# Access Compliance Report

## Public Rights-of-Way

### (Curb Ramps)

| Intersection ID: 32273 | Main Street: GREYMORE_CT | Cross Street: PRESCOTT_HILL_AV | Location: SW           |

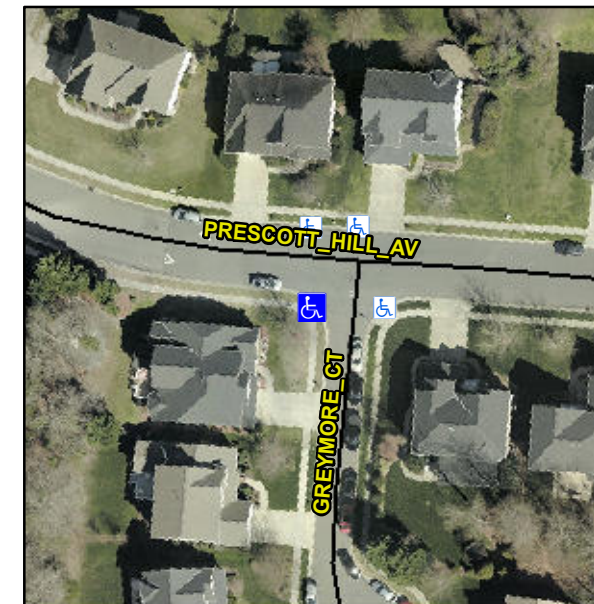
**Not Found, R304.5.1, R304.5.3**

| Compliance | Description           | Data | Compliance | Description                 | Data |
|------------|-----------------------|------|------------|-----------------------------|------|
| No         | Ramp Width (in)       | 39.0 | No         | Ramp XSlope (%)             | 5.4  |

**Remove & Replace Curb Ramp With Two New Directional Ramps or Equivalent.**
